17<sup>th</sup> December 2008

Subject: Change of the 13" Reel dimension of Tape and Reel packing of Telelink fuse 461 series, Enhanced Telelink 461E series and Omni-Blok 154 series

**Supporting document for PCN#EFU135-7**

Weight

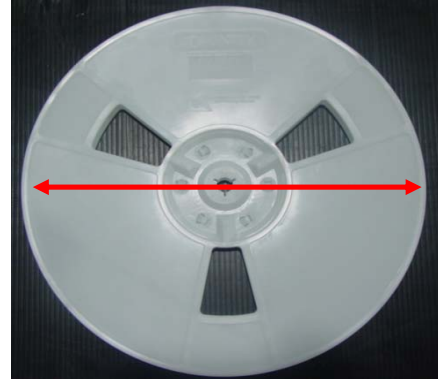
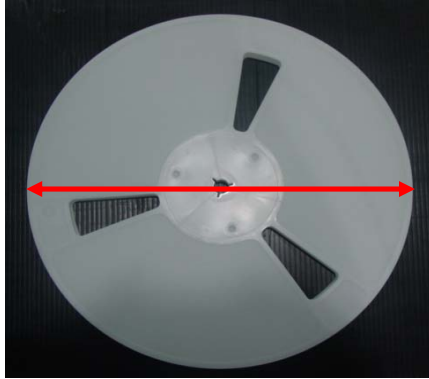
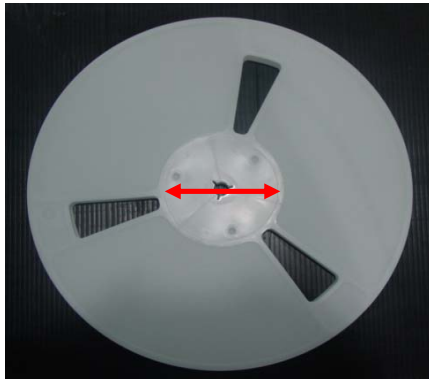
329.4 grams

292.6 grams

Diameter Outer

330 cm

330 cm

Diameter Inner

100 cm

100 cm

Slot length

76 mm

59.3 mm

Slot width inner

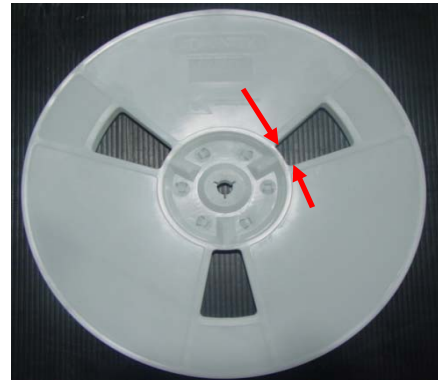
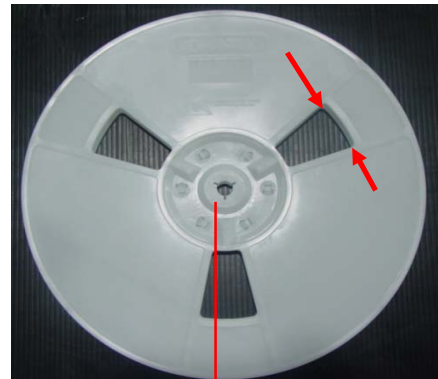
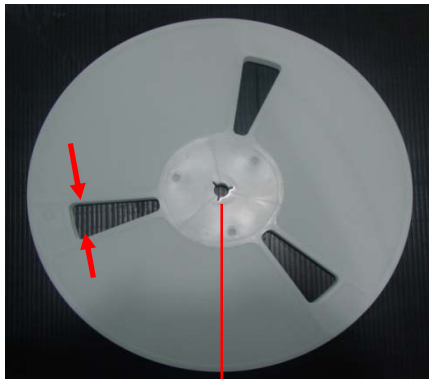
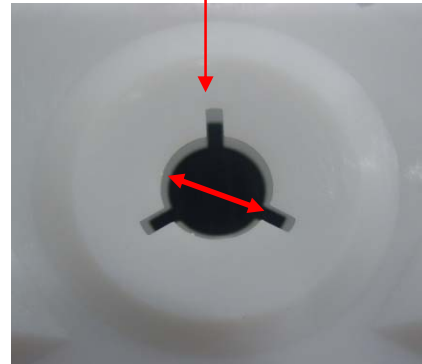
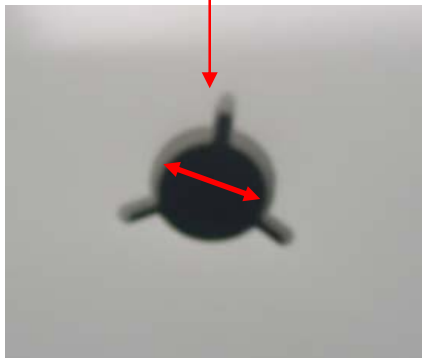
12.8 mm

24.06 mm

Slot width outer

34 mm

45.78 mm

Hole diameter

13.2 mm

13.2 mm

Rim or edge Thickness

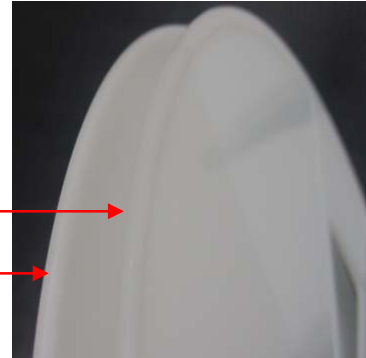
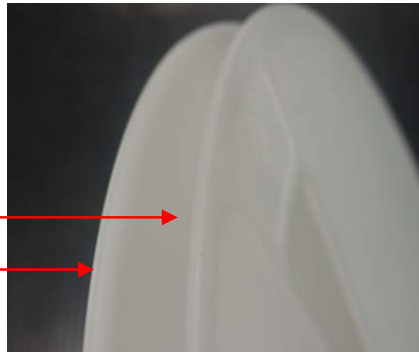
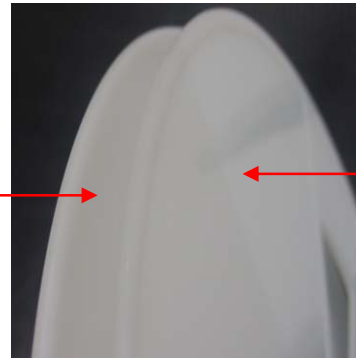
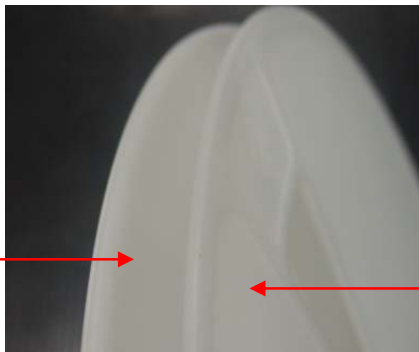
2.20 and 2.42 mm

2.18 and 2.28 mm

Surface Thickness

1.72 and 1.92 mm

1.62 and 1.72 mm

1 PART

2 Parts

Assembly

NO ASSEMBLY REQUIRED

ASSEMBLED

**Hole Wall**

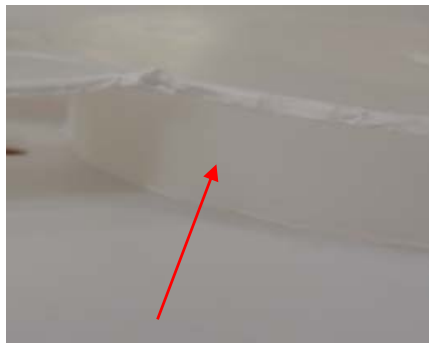
With Wall

Hollow

**Inner Spool**

Flat spool surface

V Groove spool surface

**Center surface**

Flat

Indented
